HISTORIC AND DESIGN REVIEW COMMISSION

HDRC CASE NO: 2018-638
ADDRESS: 929 BURNET ST
LEGAL DESCRIPTION: NCB 1656 BLK D LOT S 131 FT OF 17
ZONING: RM-6,H
CITY COUNCIL DIST.: 2
DISTRICT: Dignowity Hill Historic District
APPLICANT: Adan Huerta
OWNER: Adan Huerta & Juan Sanchez
TYPE OF WORK: Installation of front yard fencing
APPLICATION RECEIVED: December 20, 2018
60-DAY REVIEW: February 18, 2019
REQUEST:

The applicant is requesting a Certificate of Appropriateness for approval to construct a front yard fence.

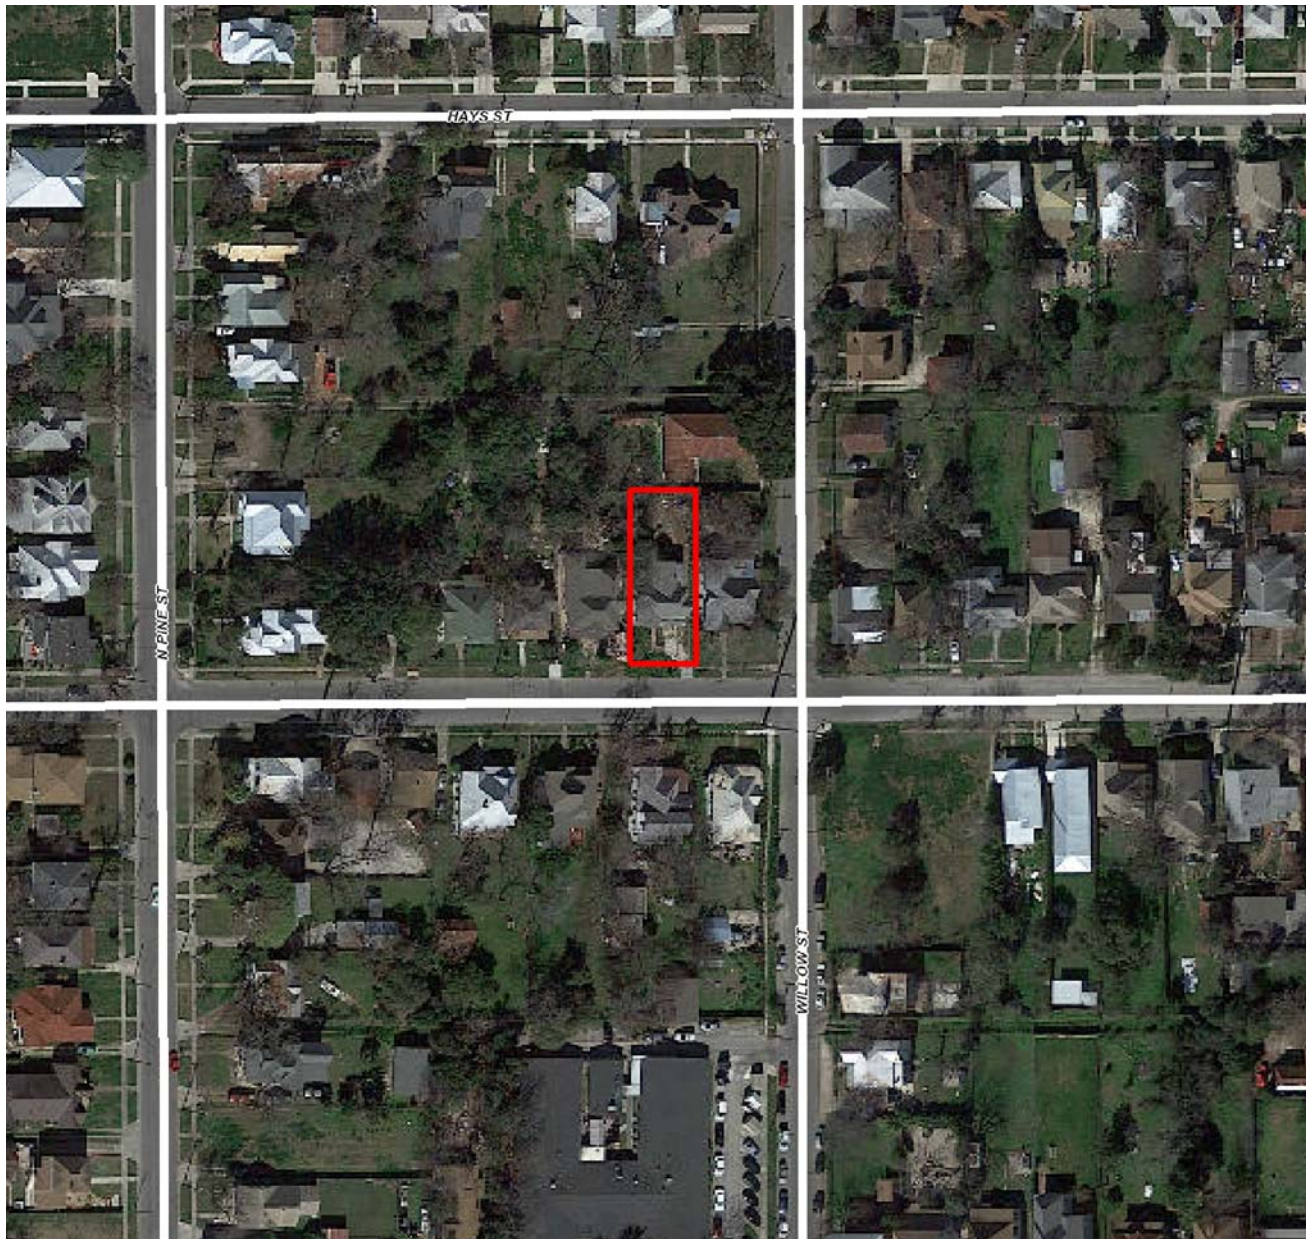
- b. FENCE LOCATION – The applicant has proposed to install a new fence that spans across the driveway instead of turning at the driveway to meet the corner of the house. According to the Historic Design Guidelines, new front yard fences should follow historic fence placements in the district. Staff finds that the fence should turn at the driveway to meet the corner of the structure, rather than spanning across the driveway as proposed.

- c. FENCE DESIGN – The applicant has proposed to install a new horizontal slat wood front yard fence. According to the Historic Design Guidelines, new front yard fences should appear similar to those used historically within the district in terms of their scale, transparency, character, and materials. The height should also be limited to a maximum of four feet. In the surrounding vicinity and within the Dignowity Hill Historic District, typical fence types for Folk Victorian style homes are vertical wood pickets and wrought iron. Staff finds the proposed horizontal slat fence is not consistent with the Guidelines.

Staff recommends approval of the new front yard fence based on findings a through c with the following stipulations:

- i. That the fence turn at the driveway to meet the corner of the structure and the driveway gate, if included, be set back behind the front façade plane of the structure, as noted in finding b.
- ii. That the fence be constructed of wood, feature a design that is more appropriate for the district, such as vertical wood picket or wrought iron, as noted in finding c. The applicant is required to submit updated documents to staff for review and approval prior to receiving a Certificate of Appropriateness.
- iii. That the fence be a maximum of four feet in height. The final construction height of an approved fence may not exceed the maximum height as approved by the HDRC at any portion of the fence. Additionally, all fences must be permitted and meet the development standards outlined in UDC Section 35-514.
